Model: Model S

Vehicle System: 40 - Rear Drive Unit

## Tech Note: Noise Path for Motor Hum

Figure 1

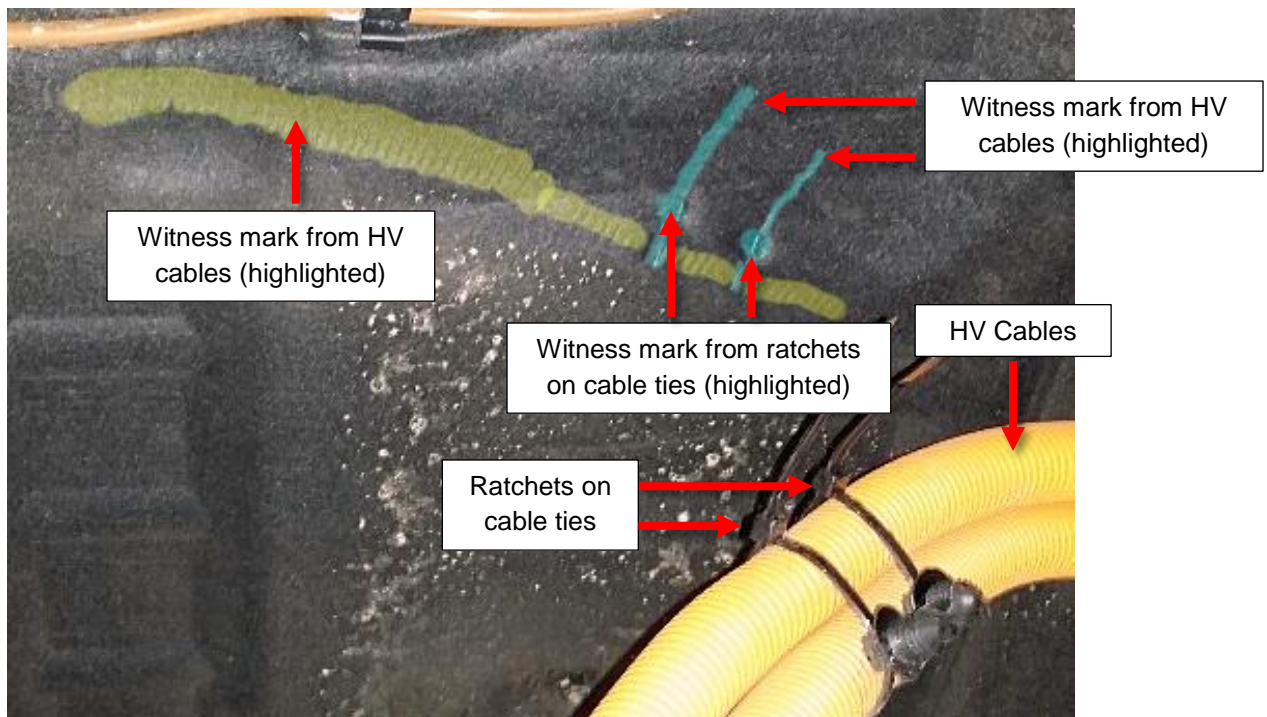
The acoustic padding above the rear subframe prevents most motor noise from entering into the cabin. However, sometimes cable ties or harnesses can press into the padding (Figure 1) or body (Figures 2 and 3), which provides a direct noise path from the motor into the cabin.

Refer to the "Installation" section of Service Manual procedure 30010201 when reinstalling the subframe to ensure that no components press into the acoustic padding.
